BIKE MODEL - CRADLE Improving Solution

A4050 Set Assemble Status

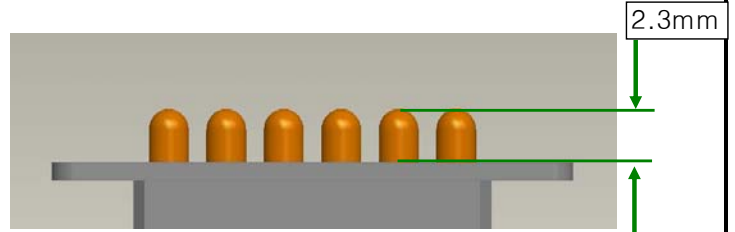
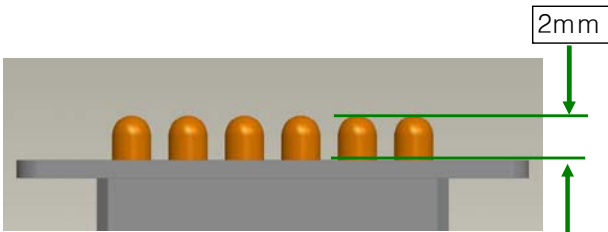
Length of Pin

When the A4050 set and Cradle assembled, the contacting area was 1mm since there was original 1mm gap from the HW set already.

After improving the pin length with additional 0.3mm longer, the contacting part from A4050 set and cradle pin gets 1.3mm. It makes stable connection & power supply.

tension

100 gf

150 gf : With strengthen tension, it's improving of any contacting defective during big vibration.
